MEMORANDUM

Project No.: 090066-002

Re: **Addendum to Draft Focused Feasibility Study
Rainier Avenue Facility Remediation**

Cross Section A-A'

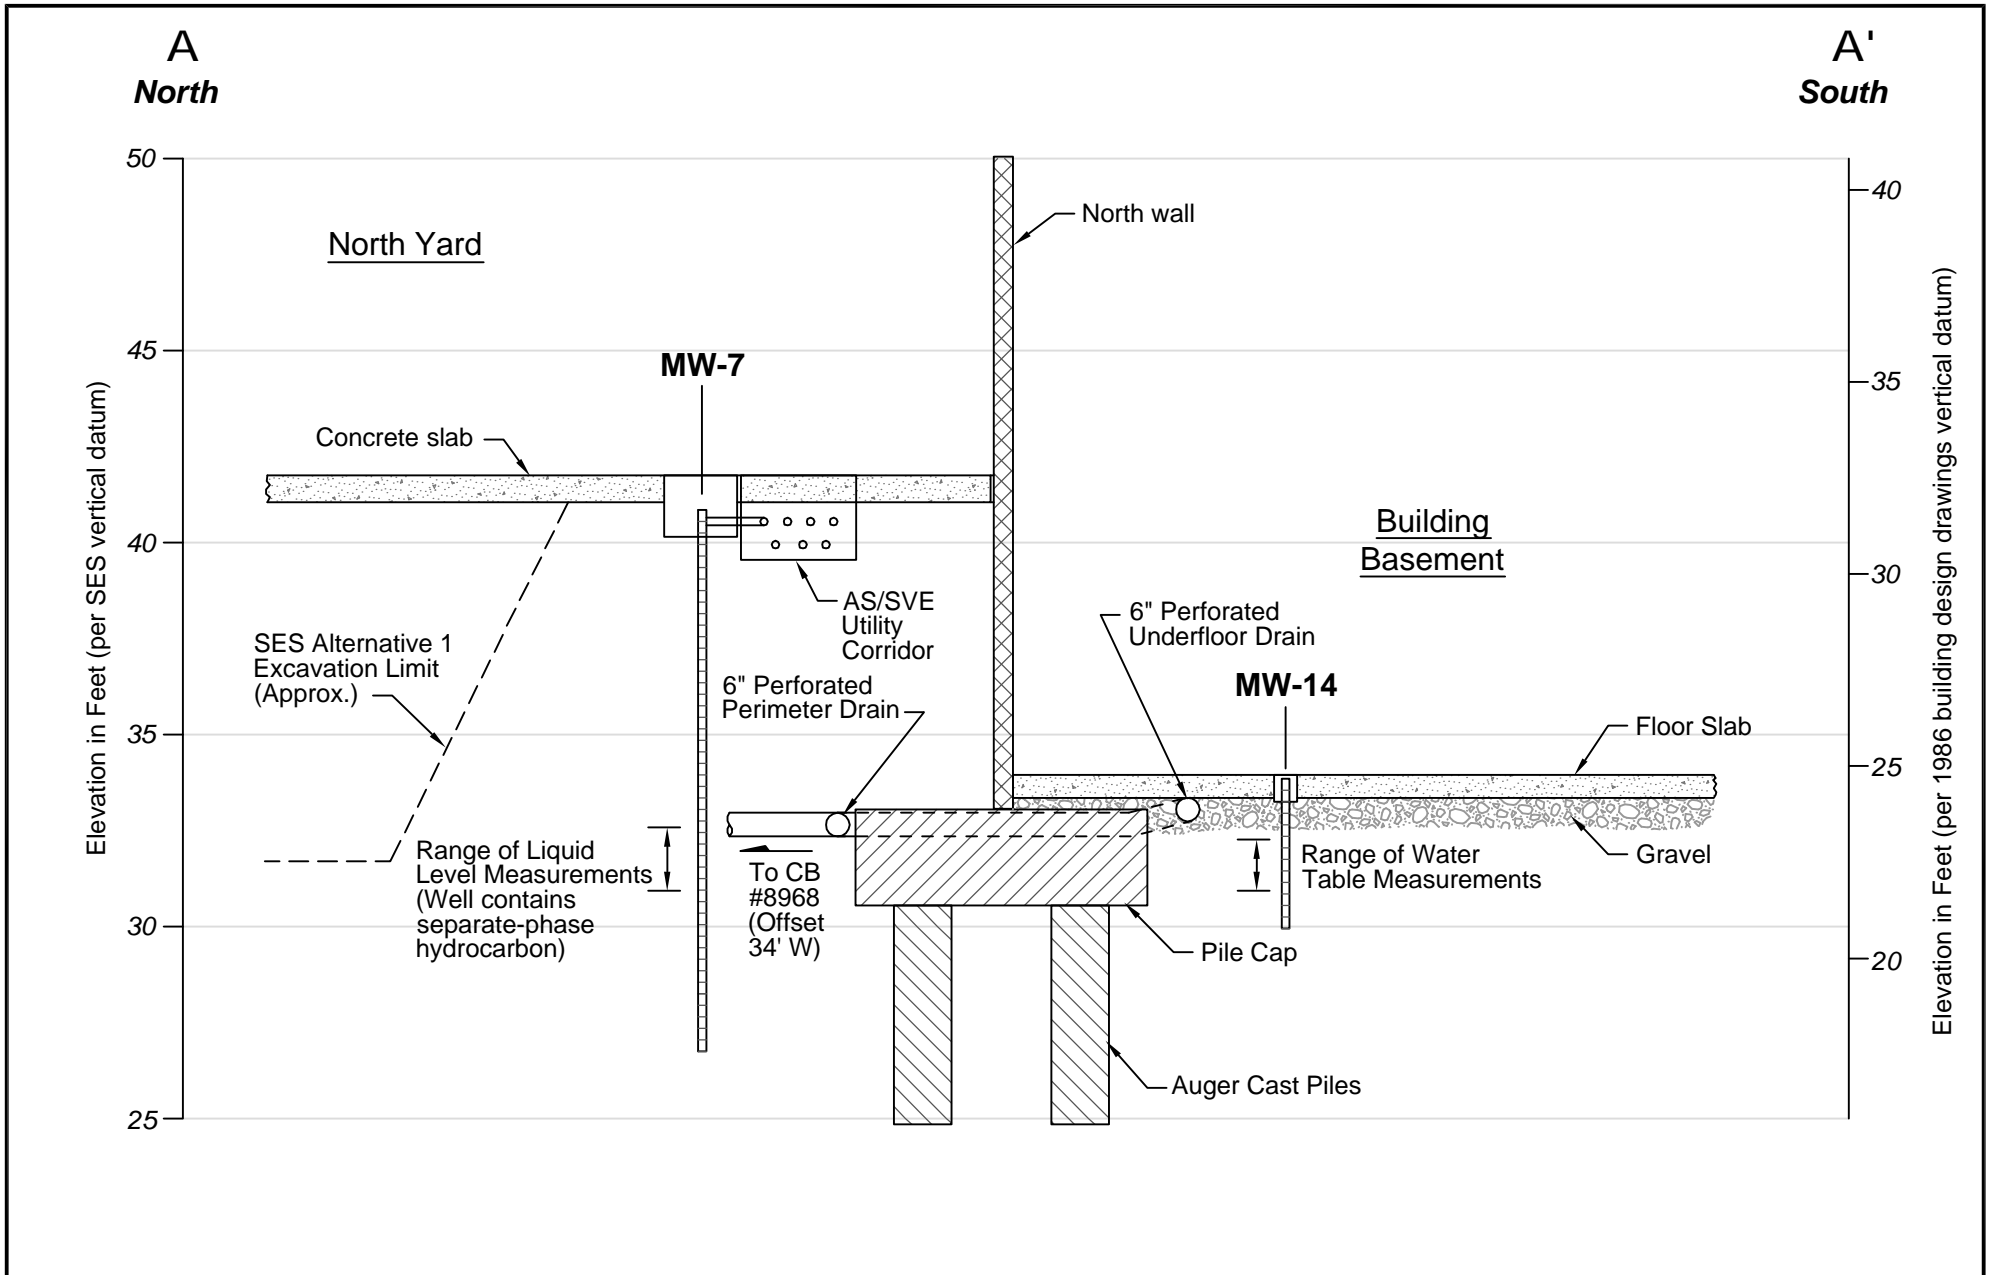
Aspect used information from SES’s *Interim Corrective Action Plan* along with the 1986 building design drawings to develop Cross Section A-A’, presented on Figure 2. (Figure 1 shows the cross section location.) The building’s north wall is supported by pairs of auger cast piles. Spaced along the wall span at intervals of approximately 22 feet on-center, the pile pairs each have individual pile caps on which the wall rests. A 6-inch-diameter perforated perimeter drain pipe runs along the upper outside corners of the pile caps, and parallel 6-inch-diameter perforated pipes located just beneath the basement floor slab are manifolded together to provide sub-slab drainage. The two drain systems discharge through a common 6-inch-diameter pipe to manhole CB#8968 in the North Yard (see Figure 1 for manhole location). From there, drainage water is routed to the storm sewer main under South Andover Street.

MW-7 and MW-14 are shown on the cross section, along with the ranges of liquid levels measured in those wells during periodic groundwater monitoring. SPH has been consistently detected floating on the groundwater in MW-7 since November 2004. MW-14, on the other hand, has not only been SPH-free, but also has had no detectable concentrations of contaminants dissolved in groundwater. Note that the top of the range measured in MW-7 is at approximately the same elevation as the nearby perimeter drain pipe. This suggests that, when the water table is high, SPH and impacted groundwater along the north wall have the potential to enter the perimeter drain pipe. (And it may help explain why contamination has not been detected beneath the building.) Storm sewer discharge from CB#8968 should be further evaluated as a potential route of offsite contaminant migration.

**Alternative 3 - Remediation Using
In Situ Technologies Only**
 Darigold - Rainier Avenue Facility
 Seattle, Washington

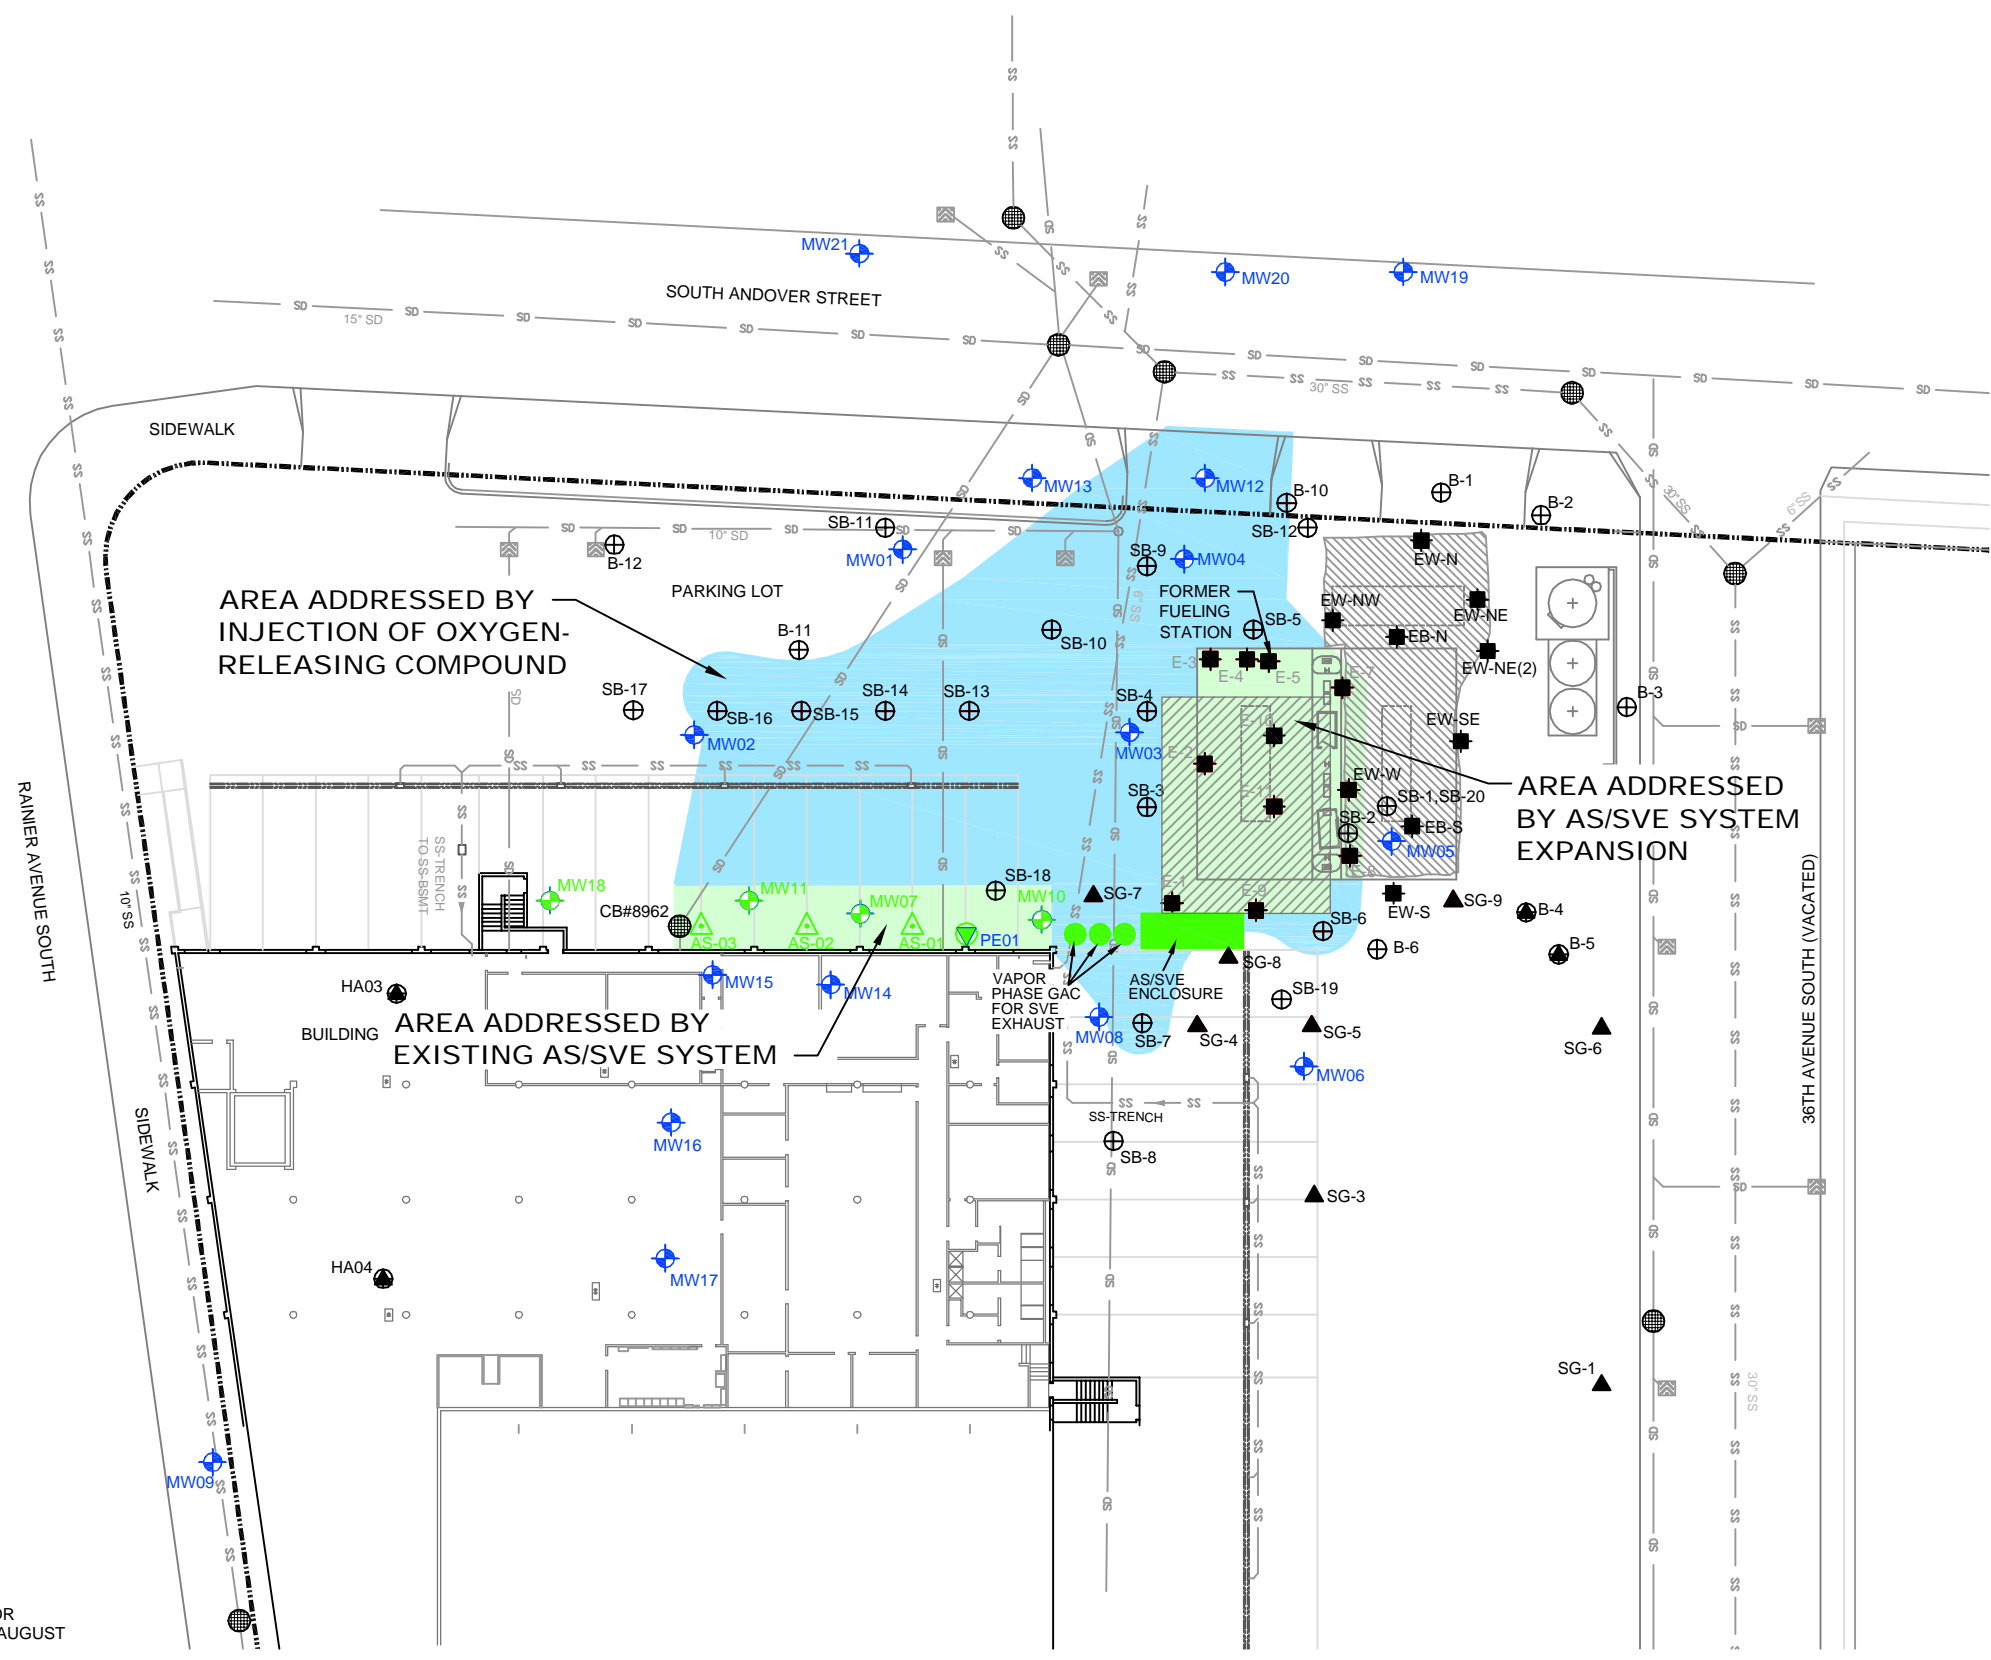
In the remaining areas of impact, where less permeable soils would likely impede AS/SVE effectiveness, injection of oxygen-releasing compound is proposed. Figure 4 shows the estimated area to be addressed by this technology. Injection of oxygen-releasing compound to accelerate biodegradation of contaminants is discussed in Section 4.5.1 of the draft FFS. We concur with SES that this is a promising *in situ* technology for application at this site, and that pilot testing is warranted. The goals of pilot-testing injection of oxygen-releasing compound would include the following:

Alternative 5 - Extensive Excavation
 Darigold - Rainier Avenue Facility
 Seattle, Washington

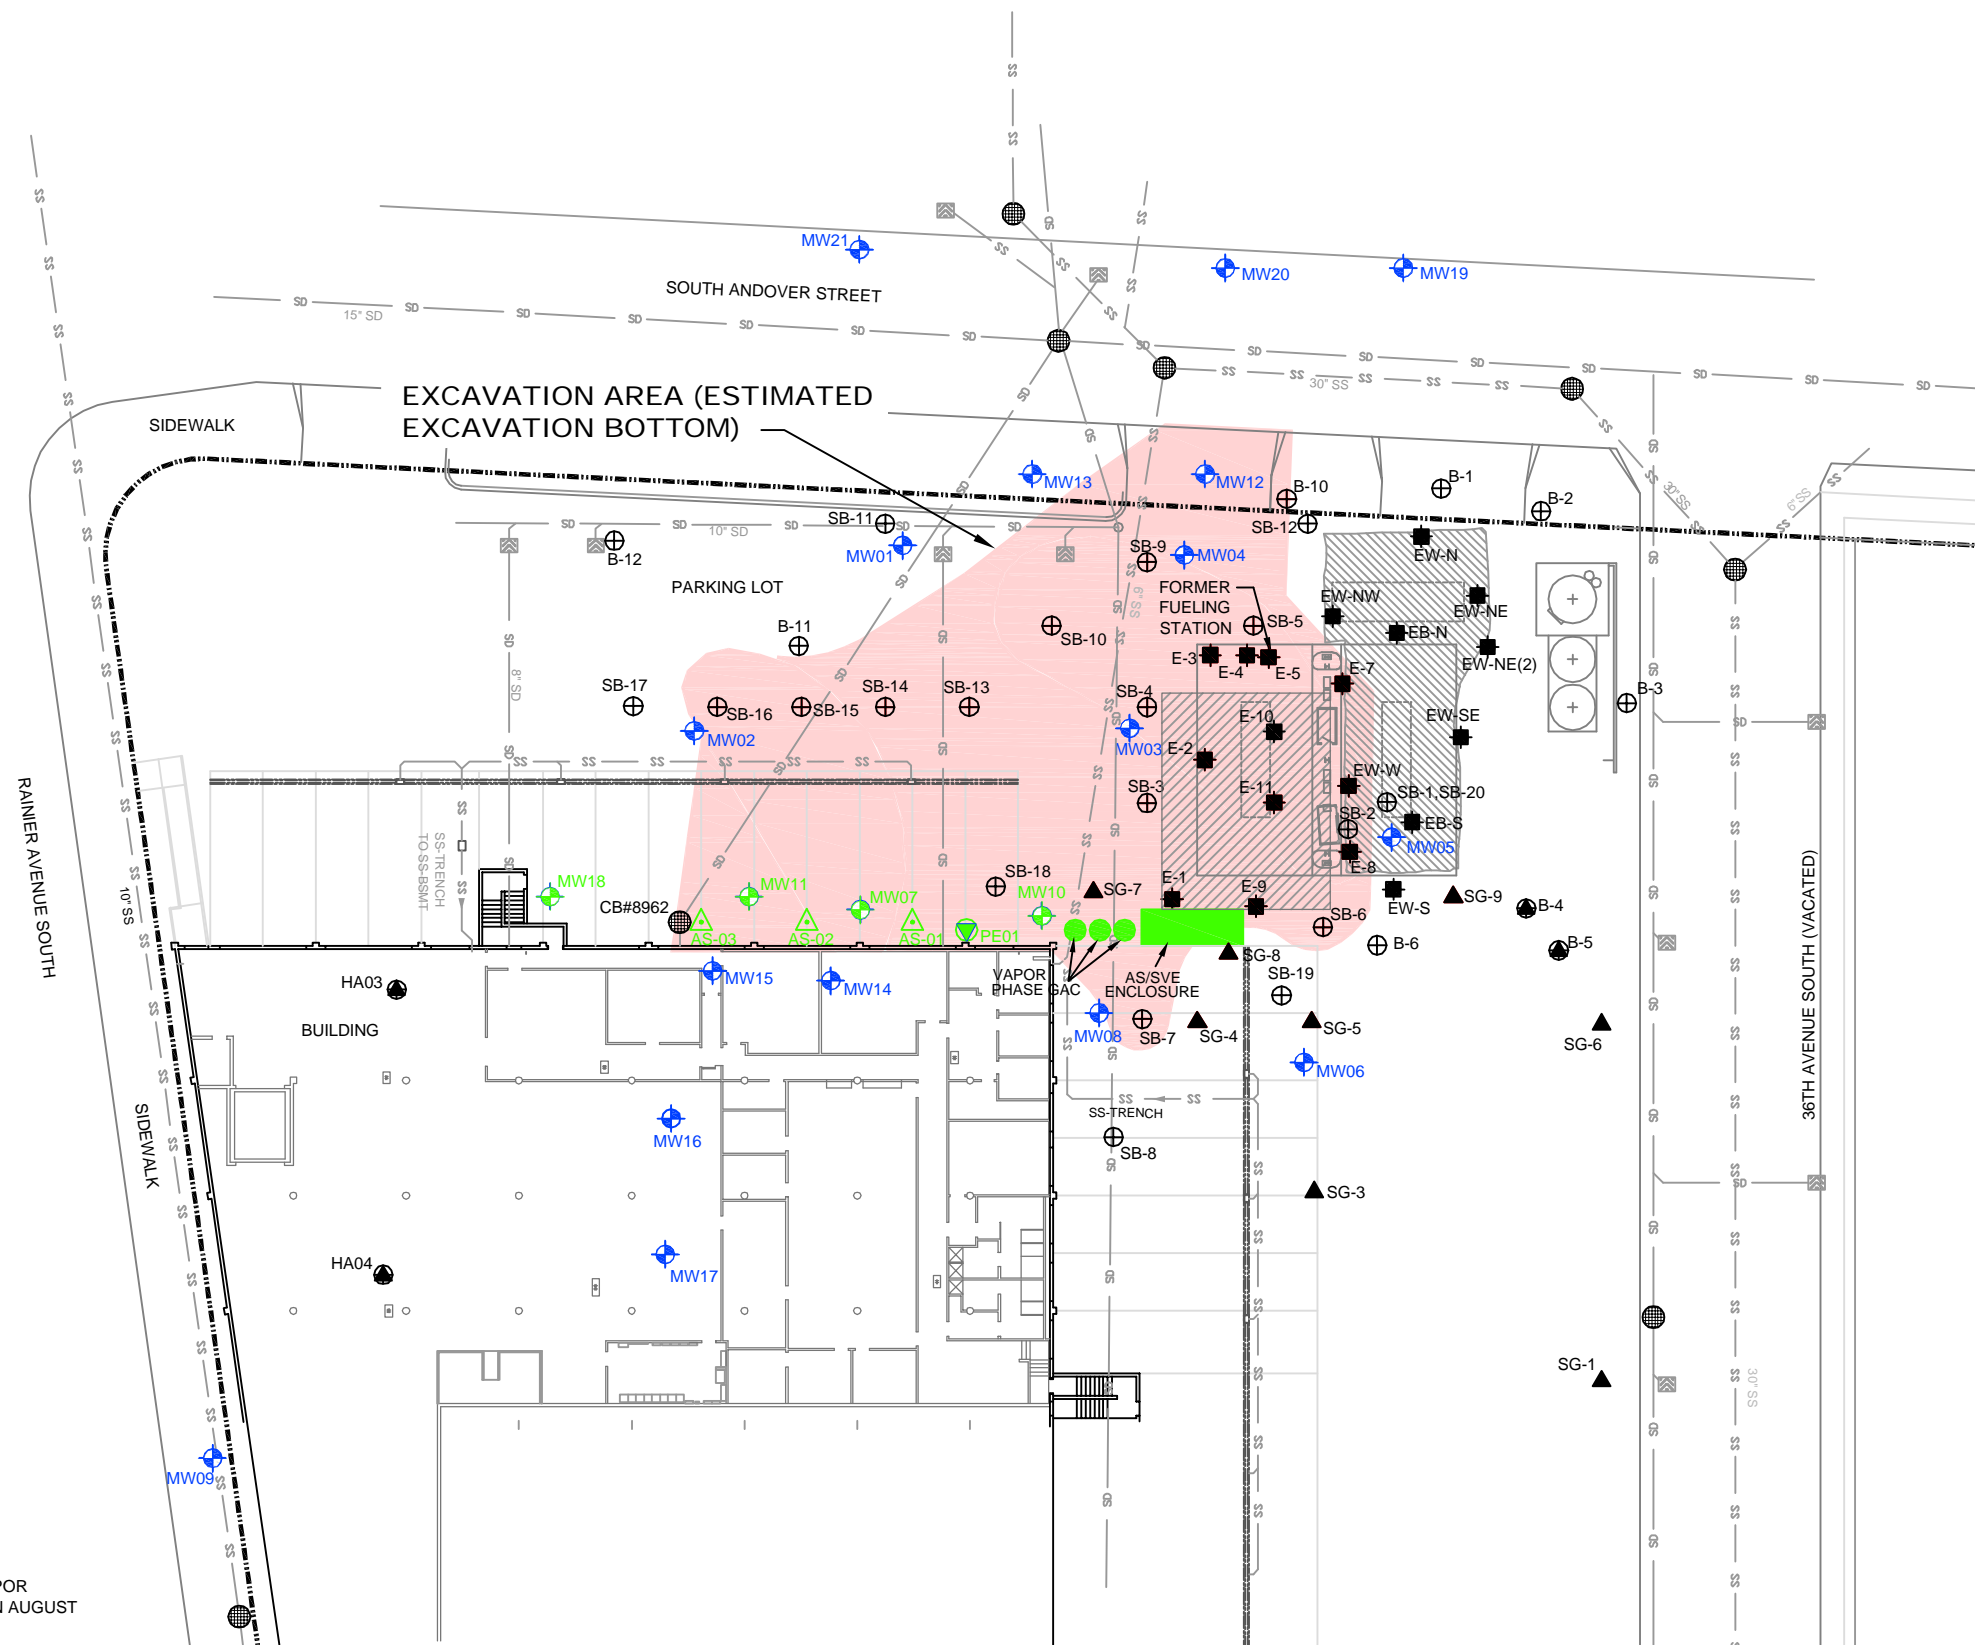
This alternative is intended to be comparable to SES 3. Note that the boundaries of the estimated excavation area shown on Figure 6 are somewhat different than those depicted by SES on Figure 10 of the draft FFS. However, the estimated volume of soil requiring excavation is nearly the same in both cases (roughly 6,000 cy). The actual extent of impacted soils requiring excavation would be determined by completing characterization trenches (described in Section 4.5.1 of the draft FFS) and by monitoring during excavation.
